# Access Compliance Report

## Public Rights-of-Way

Intersection ID: 27649	Main Street: BALLANTYNE_COUNTRY_CLUB_DR	Cross Street: ROBINSON_ROCK_CT	Location: SW
ADA ID: B10194F05E52	Ramp Type: Perp	Initial Pass/Fail: Fail	Overall Compliance: No
Severity Score: 10			
Codes/Mitigation Info/Possible Solution		Field Measurements/Component Compliance

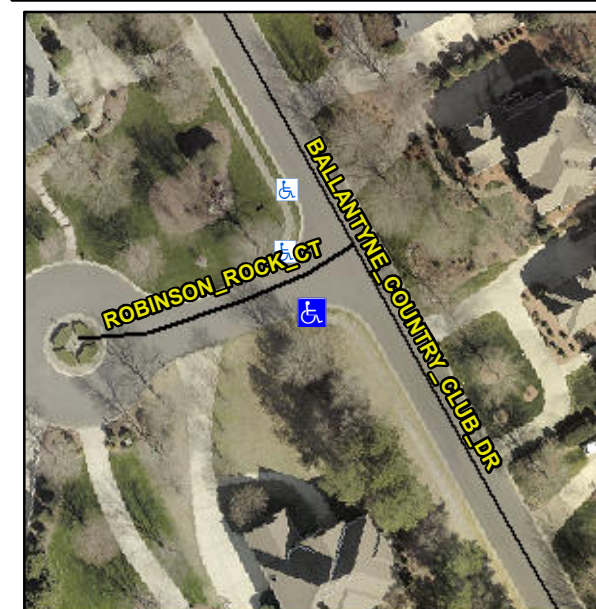
**Remove & Replace Entire Ramp.**

**Not Found, R304.5.1, R304.5.3**

Compliance	Description	Data	Compliance	Description	Data
N/A	Ramp Length (in)	44.0	Yes	Ramp Slope (%)	6.7
No	Ramp Width (in)	39.0	No	Ramp XSlope (%)	3.4
N/A	Flare Type LT	N/A	N/A	Flare Type RT	N/A
N/A	Flare Slope LT (%)	N/A	N/A	Flare Slope RT (%)	N/A
N/A	Flare Traversable LT?	N/A	N/A	Flare Traversable RT?	N/A
N/A	Landing Length (in)	N/A	N/A	DWS Provided?	N/A
N/A	Landing Width (in)	N/A	N/A	DWS Contrast?	N/A
N/A	Landing Slope (%)	N/A	N/A	DWS Length (in)	N/A
N/A	Landing X Slope (%)	N/A	N/A	DWS Full Width?	N/A
N/A	Landing Curb? (Y/N)	N/A	N/A	DWS Offset (in)	N/A
N/A	Shared Landing?	N/A			
N/A	Gutter Ponding?	N/A	N/A	Gutter Slope (%)	N/A
N/A	Gutter Lip Ht (in)	N/A	N/A	Gutter X Slope (%)	N/A
N/A	Painted X Walk1?	No	N/A	Painted X Walk2?	N/A
	X Walk 1 Direction	To N		X Walk 2 Direction	N/A
N/A	X Walk 1 Width (in)	N/A	N/A	X Walk 2 Width (in)	N/A
	X Walk 1 Slope (%)	1.4		X Walk 2 Slope (%)	N/A
	X Walk 1 X Slope (%)	2.3		X Walk 2 X Slope (%)	N/A
